REMARKS

Applicant respectfully requests reconsideration of the subject application in view of the amendments and remarks set forth herein. Applicant notes that attached to this amendment is a request to Change Attorney Docket Number. Applicant further notes that the Examiner, in rejecting the claims under 35 U.S.C. 112, 2nd paragraph, suggests that the claims appear to be a literal translation into English from a foreign document. Applicant respectfully submits the application was drafted in English in Australia, as was the complete specification for the PCT application.

1. Objections to the Drawings

FIG. 4

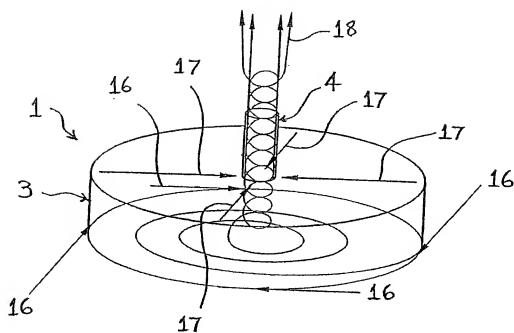
and “said primary lower layer and said secondary upper layer interact and support each other in a non-destructive manner from peripheral side wall to said outlet”. The applicant submits that support for the amendment is found in the specification with particular reference to a description of Fig. 4 at page 6, last paragraph through to page 7.

claimed by the Applicant in amended claim 1 of the application. As can be seen in Fig. 4 of the Applicant's disclosure, the "primary lower layer" enters the chamber 1 from an inlet that is tangential to peripheral side wall 3 (outer perimeter) to create a vortex motion towards the center. The secondary upper layer 17 enters the chamber 1 from an inlet that is perpendicular and its direction of flow is radial. Please note that the arrows 16 represent the primary lower layer in Fig. 4 which are clearly tangential and the arrows 17 represent the secondary upper layer and are clearly radial. As clearly stated in the description, the primary lower layer 16 and the secondary upper layer 17 interact (mix) and support each other from the perimeter (side wall 3) to the central outlet 4 (recited in amended claim 1 as "support each other in a non-destructive manner from peripheral side wall to said outlet." The presence of these upper and lower layers do not break up the motion and effects of the vortex, but rather enlarge and heighten the effect of the vortex as the fluid moves towards the central axis (outlet 4).

FIG. 6

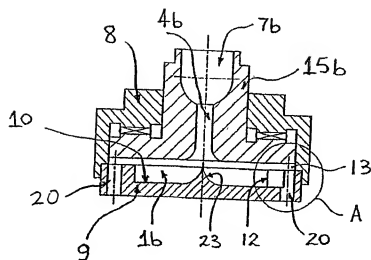
The Examiner has objected to the drawings for allegedly failing to show every feature of the invention specified in the claims. (See e.g., paragraph 2 of the Office Action.) Particularly, the Examiner states, “the ‘shower head’ of claim 7, the ‘plurality of inlets’ in claim 8 must be shown or the feature(s) canceled from the claim(s).” Applicant has amended claim 7 to recite the subject matter referenced by the Examiner directed to a “plurality of inlets” and claim 8 is amended to depend from claim 7 reciting the subject matter directed to a “shower head”. Applicant further amends Figures 5, 6 and 8 by way of the attached replacement sheets and annotated sheets to more clearly illustrate the subject matter of the present disclosure. Particularly, Applicant has set forth additional reference numerals (20) in Figure 5, 6 and 8 to clearly illustrate to the Examiner that the present disclosure illustrates embodiments having a plurality of apertures (20), each aperture (20) is associated with an inlet (11) thereby illustrating a plurality of inlets as recited by amended claim 7. (See Fig. 8, and specification, page 8, lines 3-5, “However, a portion of the flow as it passes through *the eight apertures 20* associated with *inlet ports 11* is urged circumferentially into the annular gap 13 between disc 9 and shower housing 15a or 15b.”) (*Emphasis Added.*)

Referring to amended claim 8 reciting at least in part “a shower head,” Applicant respectfully submits that the specification including the drawings fully support this claim recitation. In particular, the specification refers to several embodiments illustrated by the drawings as being a “shower head” in an exemplary embodiment. Applicant respectfully directs the Examiner to view Figures 5 and 6 in light of the description found on page 7 of the specification which states, “FIGS. 5 and 6 depict second and third embodiments of a *“shower head”* apparatus for regulating fluid flow through a spray nozzle that produce the primary lower layer 16 and secondary upper layer 17 flow conditions described with reference to the first embodiment of the invention shown in FIG. 4. FIG. 5 depicts a *shower head* having a “fixed volume” circular chamber 1a, whilst FIG. 6 depicts a *shower head* having a “variable volume” circular chamber 1b.” (*Emphasis Added.*)

Applicant respectfully submits that the drawings in view of the specification are sufficient to enable one having ordinary skill in the art to fully understand and appreciate that the apparatus associated with the present disclosure, at least in one embodiment, is a “shower head” as described at least by the passage cited above and in view of at least Figures 5 and 6

5, 6 and 8 and a second set of amended drawings titled "Annotated Sheets" showing a marked-up version of the amended Figures 5, 6 and 8. Applicant respectfully submits that no new matter is introduced by way of the foregoing drawing amendments.

FIG. 8

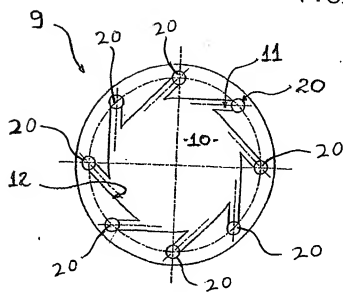
A plurality of inlets (11) is shown in the original drawings as filed, particularly with reference to Figure 8, however, to more clearly illustrate to the Examiner that the drawings illustrate every feature of the invention specified in the claims, the amendments to the drawings are made to include referencing each aperture (20) associated with an inlet (11).
